**Addendum No. 3**

**Final Environmental Impact Report  
for Metro Gold Line Foothill Extension - Azusa  
to Montclair (SCH 2010121069)**

**Evaluating Minor Design Changes of the Project  
Azusa to Montclair**

Metro Gold Line Foothill Extension Construction Authority  
March 2016

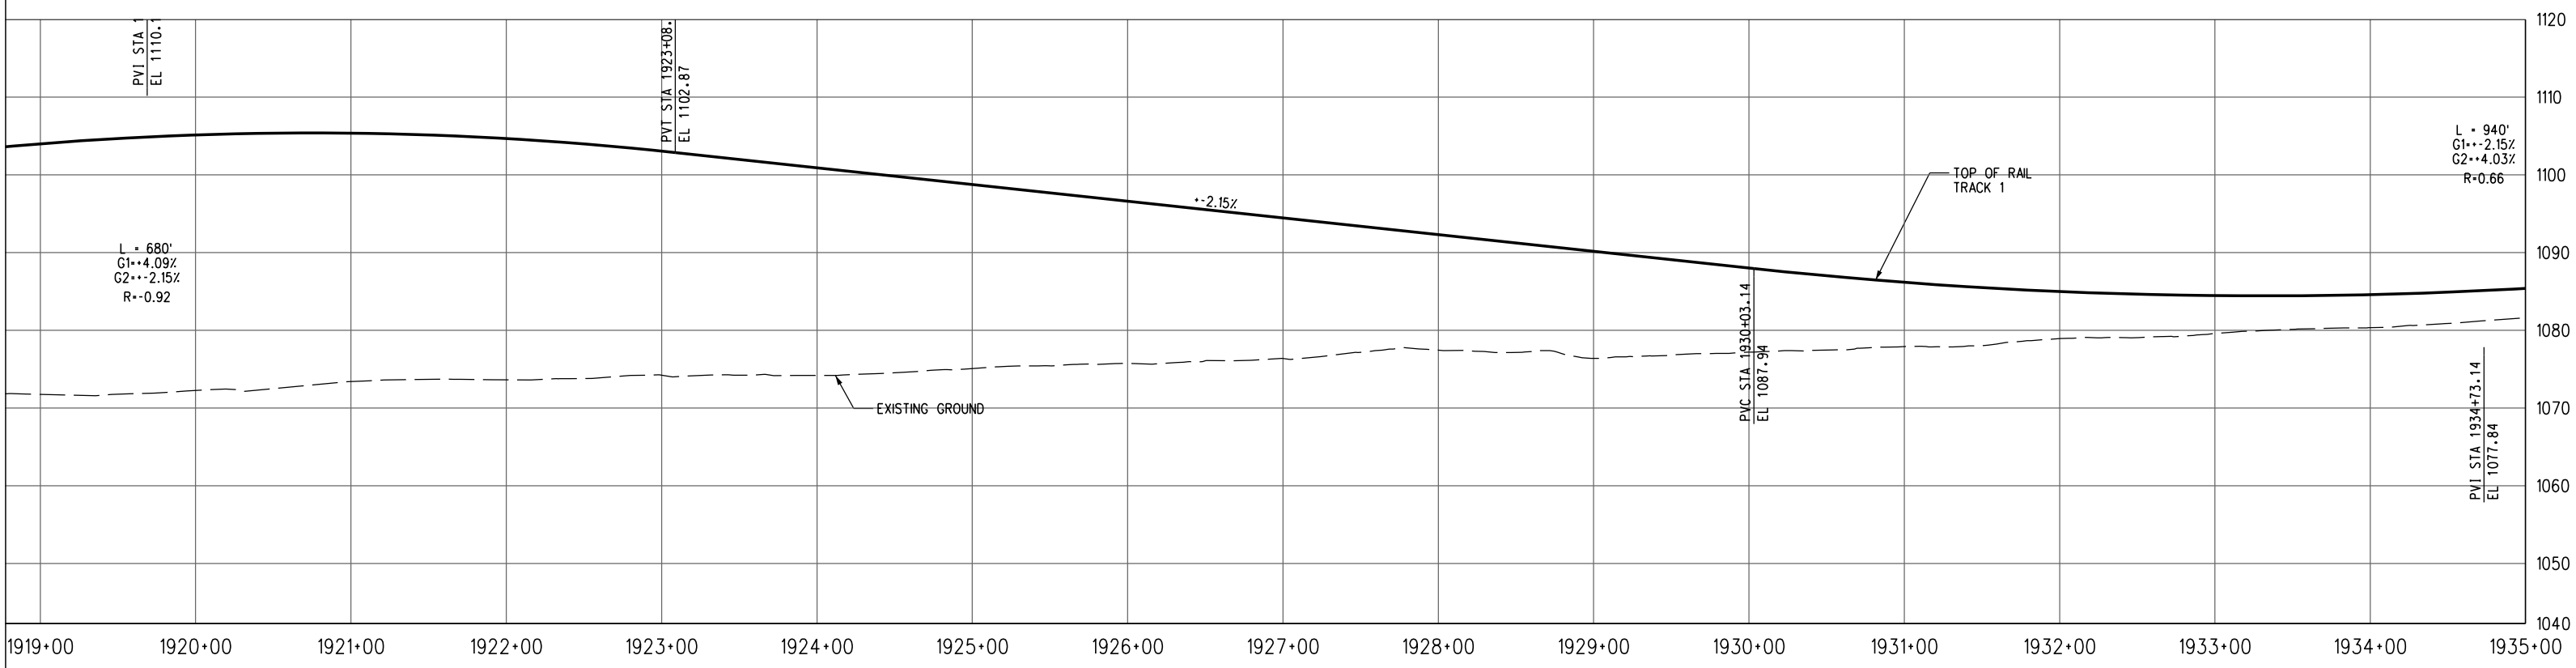
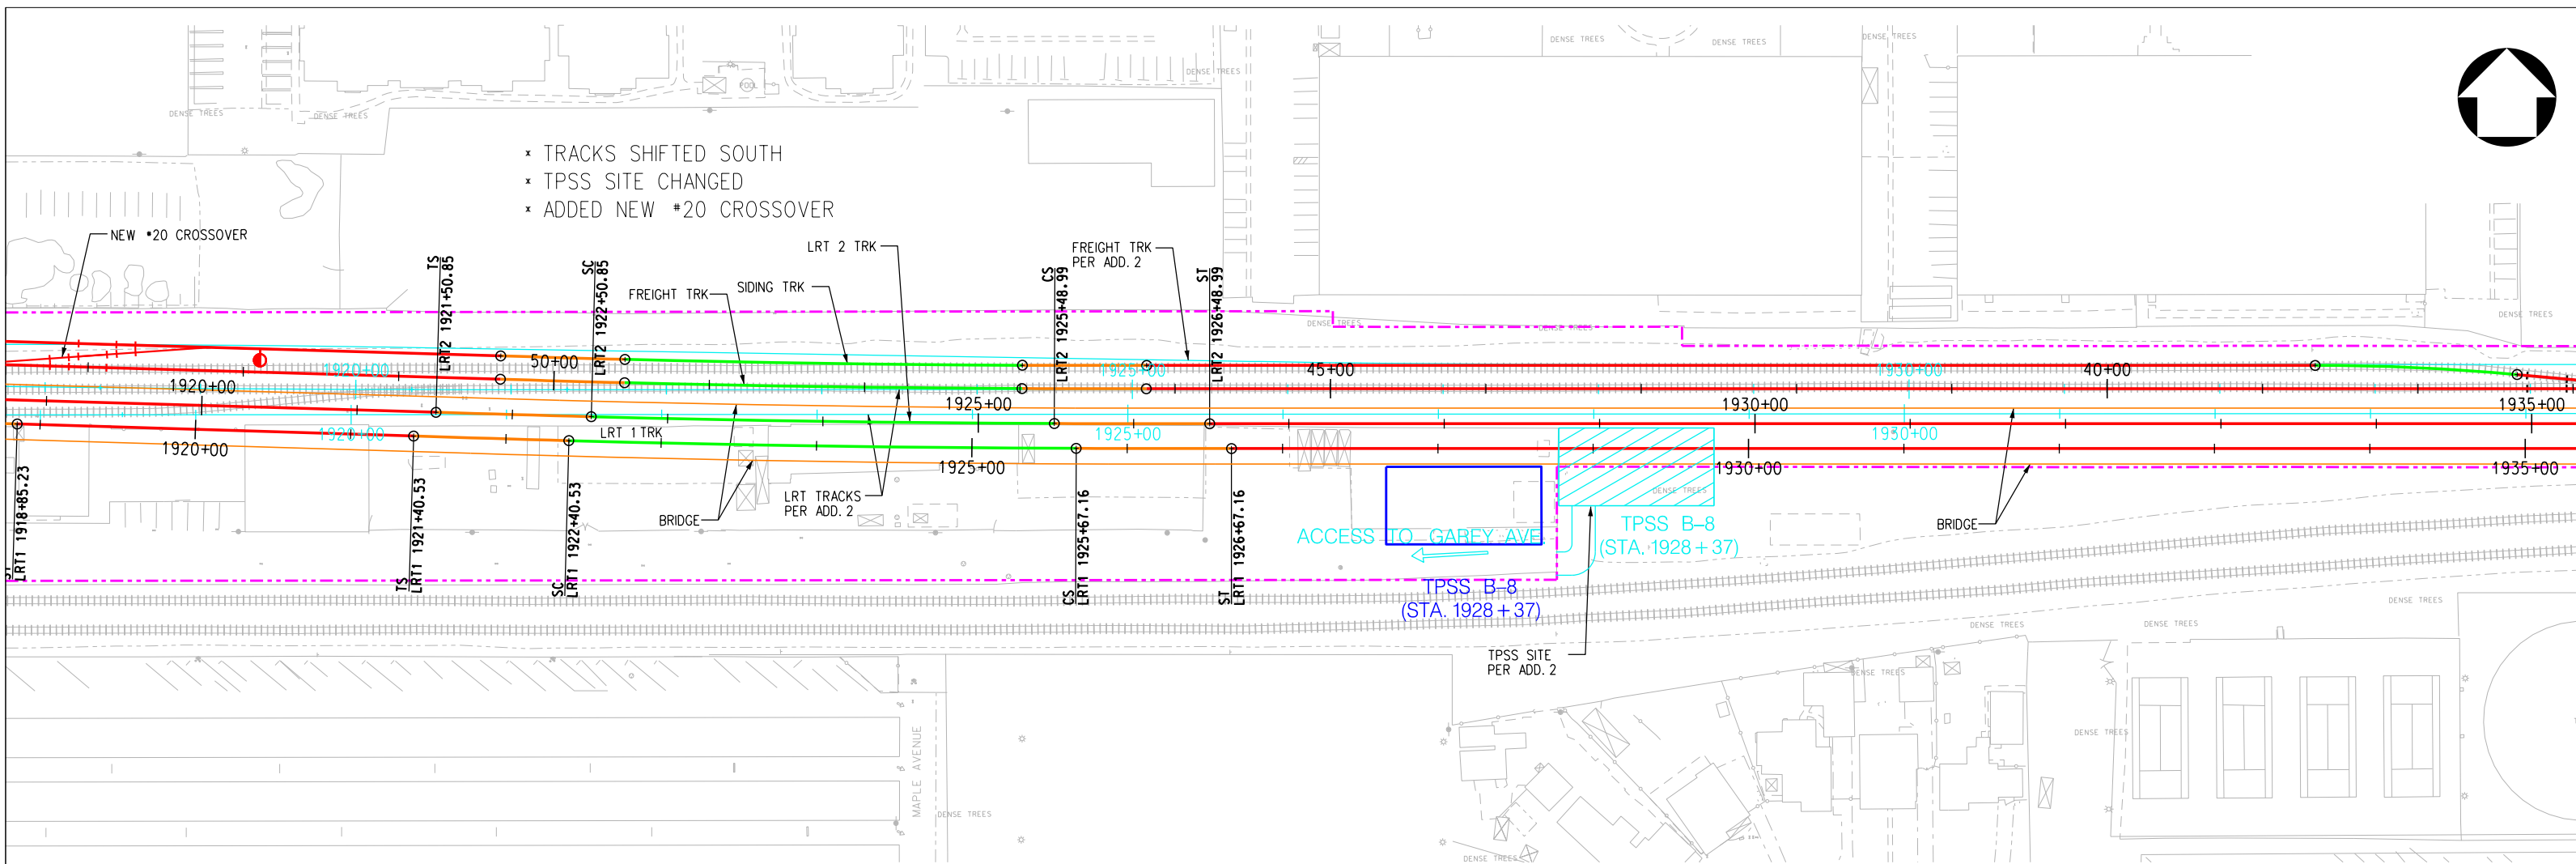
- \* TRACKS SHIFTED SOUTH
- \* TPSS SITE CHANGED
- \* ADDED NEW #20 CROSSOVER

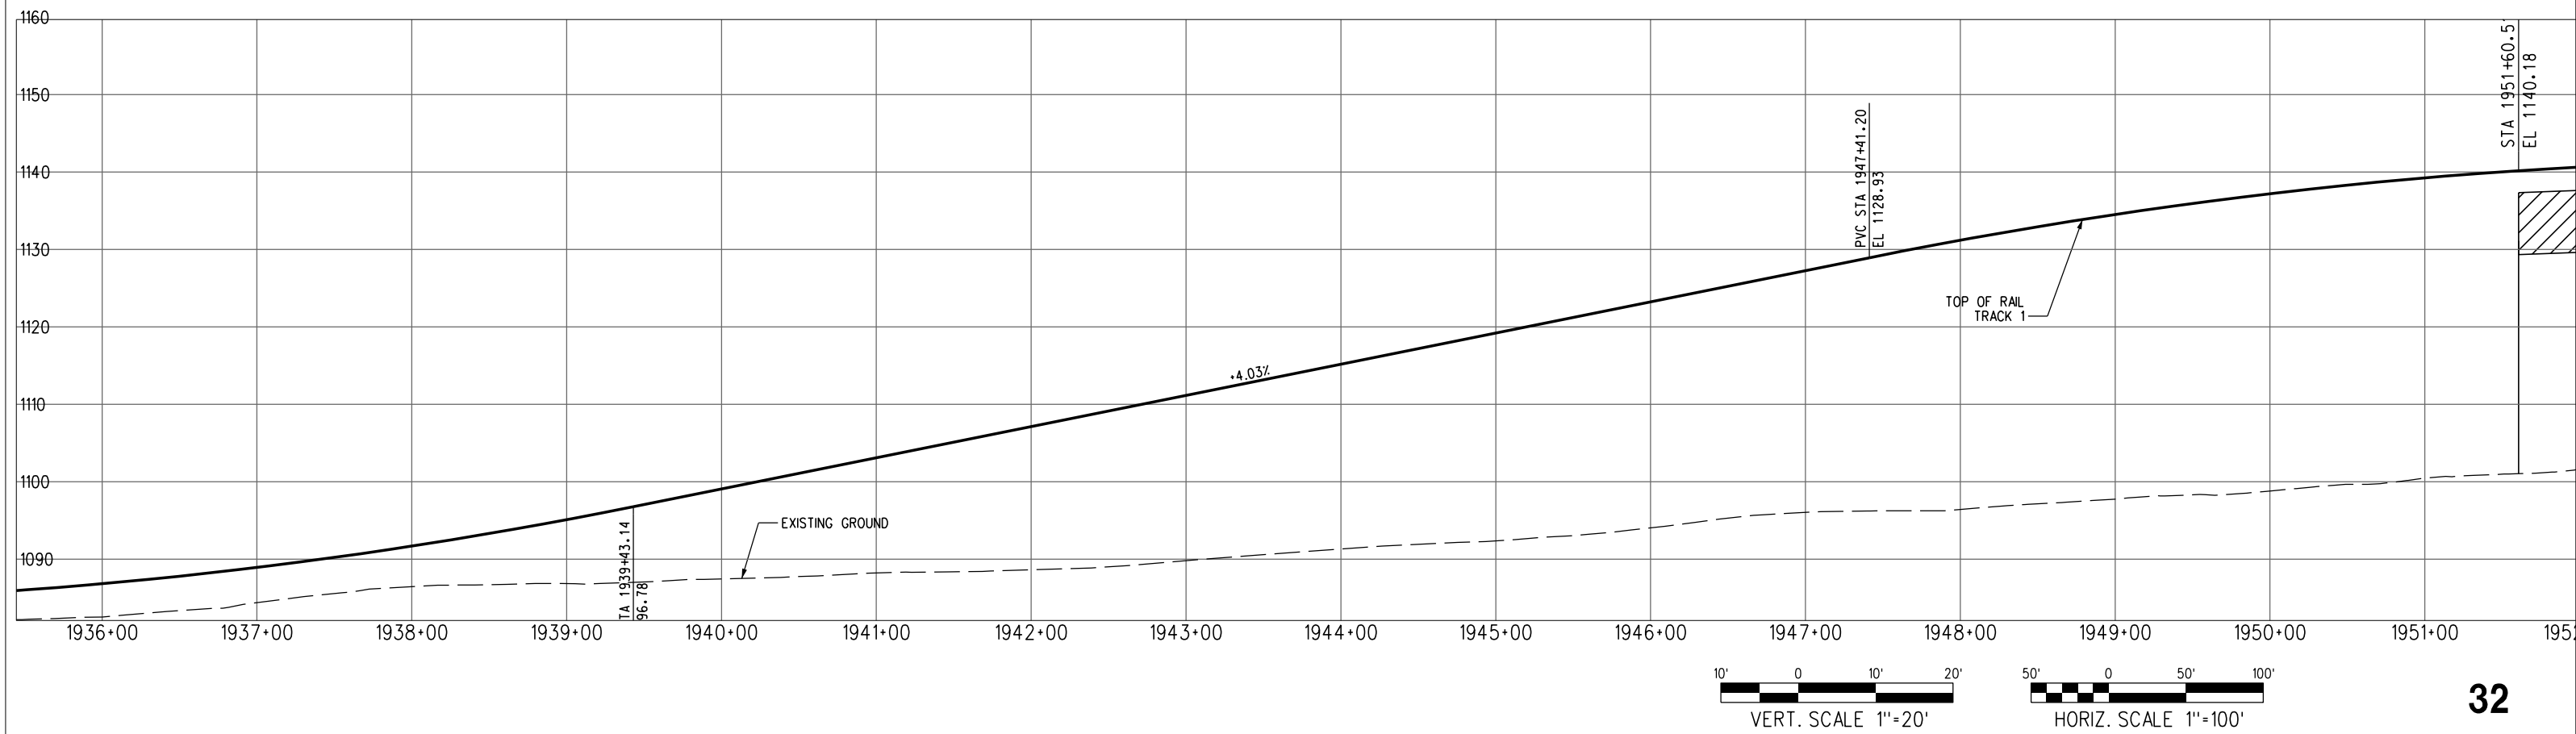
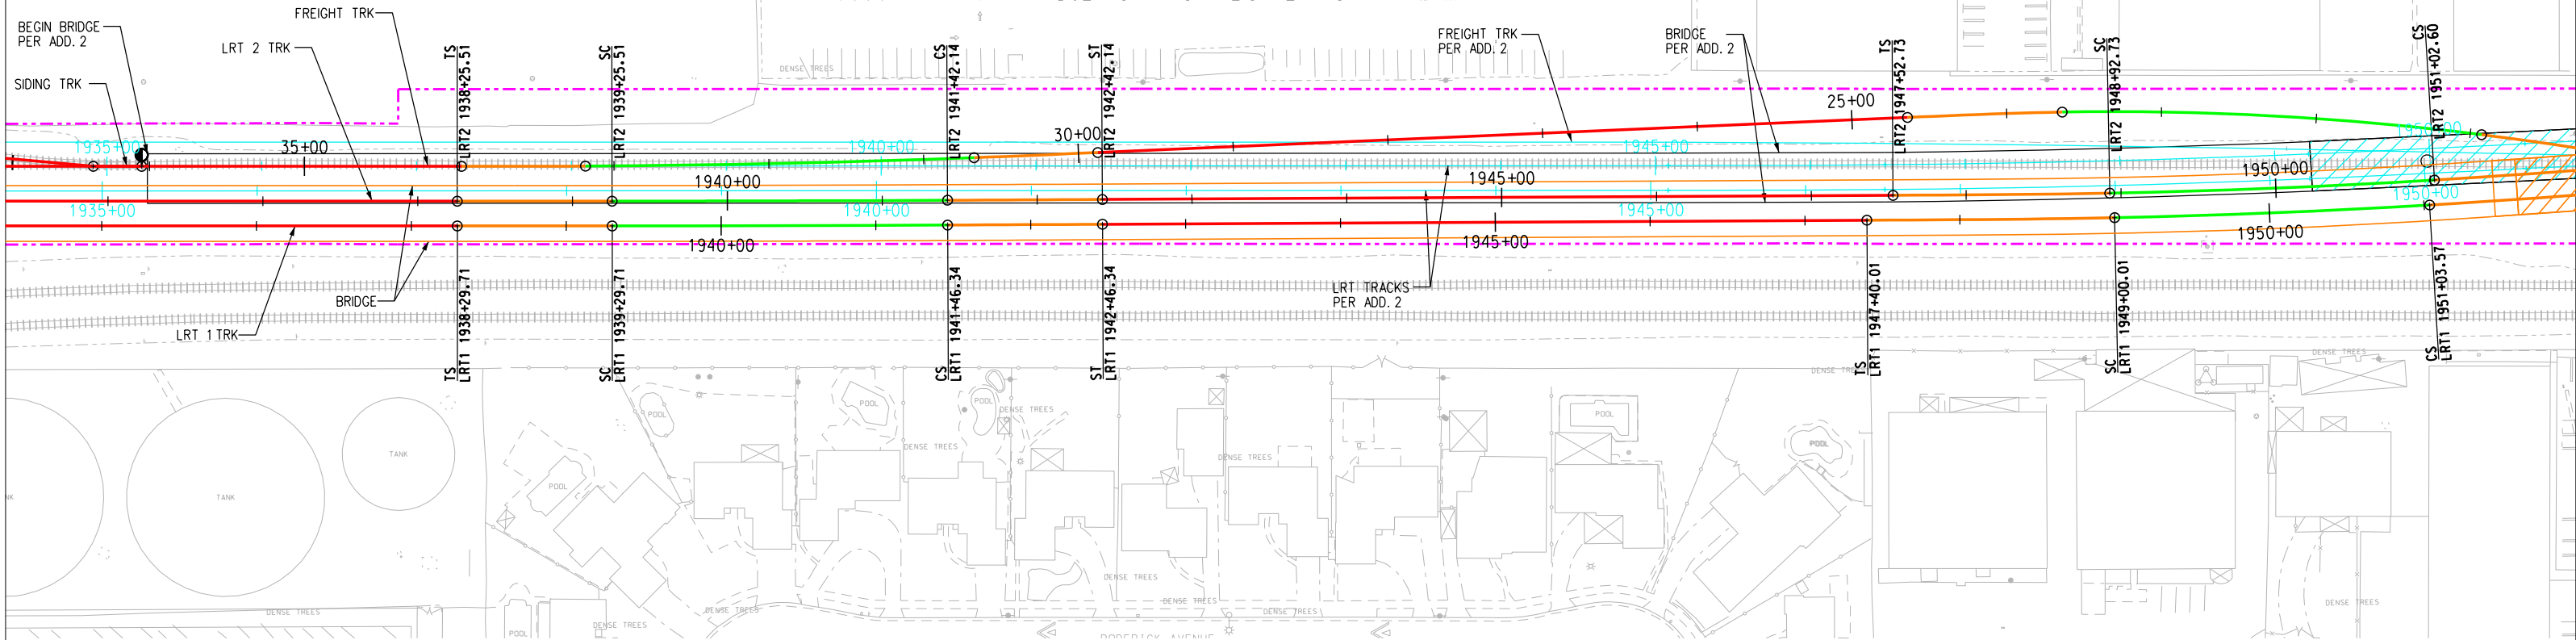
- \* TRACKS SHIFTED SOUTH
- \* END OF SIDING TRACK
- \* ADD SWITCH FOR SIDING
- \* DIFFERENT BRIDGE CONFIGURATION DUE TO TRACK ALIGNMENT SHIFT

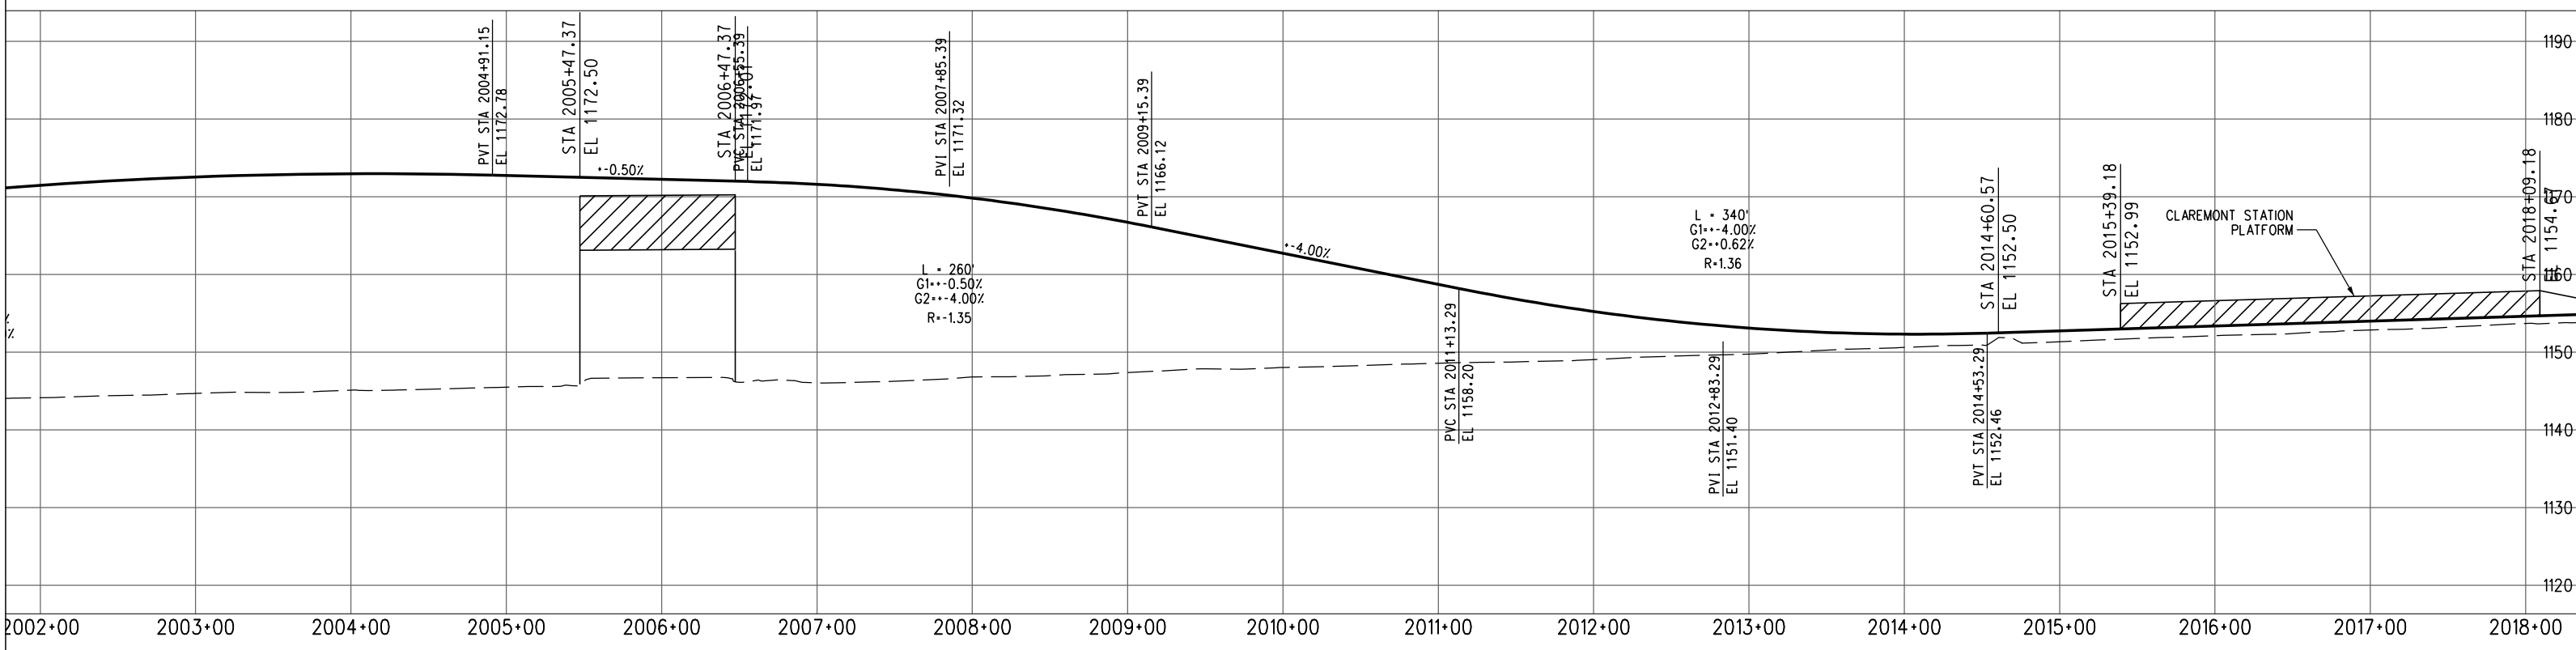
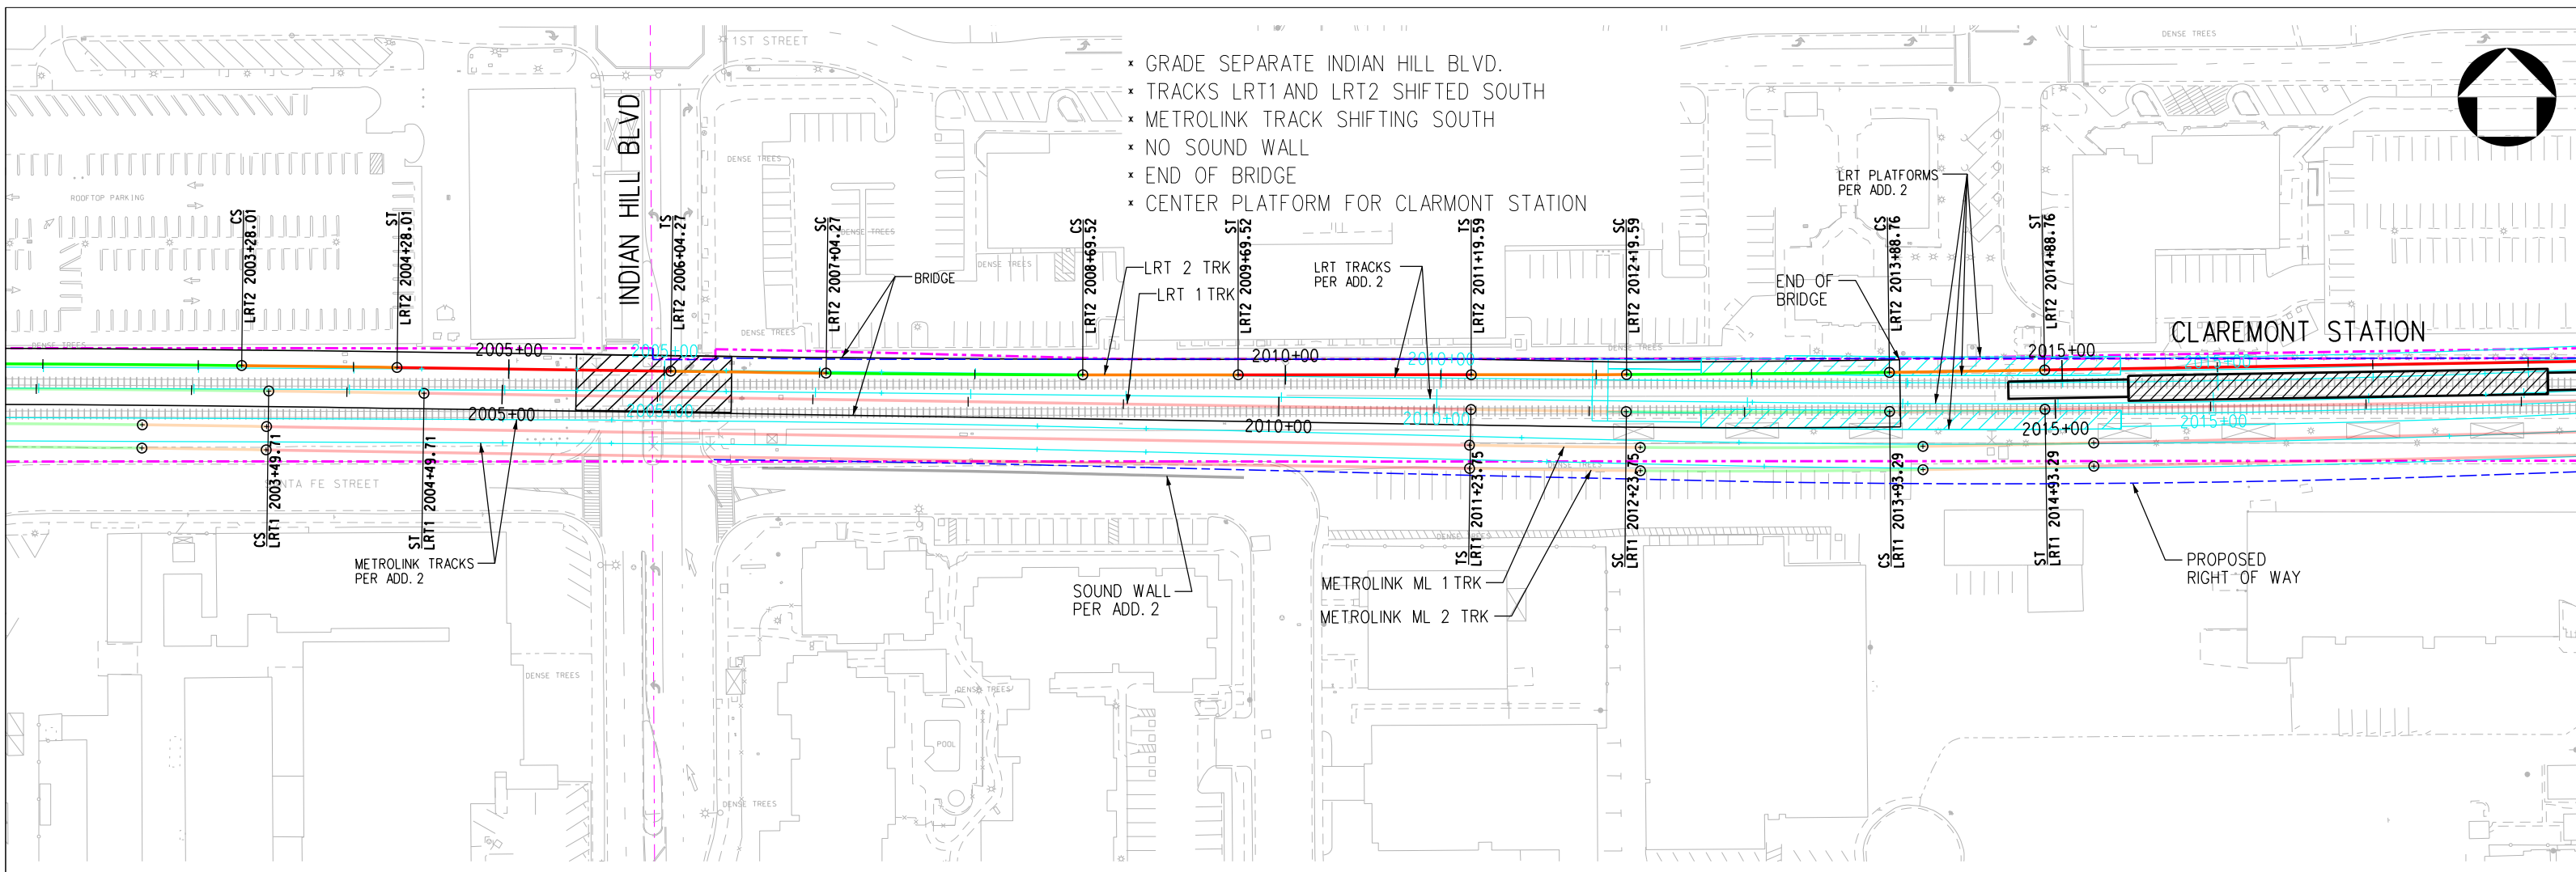
- ✦ TRACKS LRT1 AND LRT2 SHIFTED NORTH
- ✦ ADDING NO. 20 TURNOUT TO JOIN FREIGHT TRACK WITH METROLINK TRACK
- ✦ FREIGHT TRACK SHIFTED SOUTH AND JOINS EXISTING METROLINK TRACKS
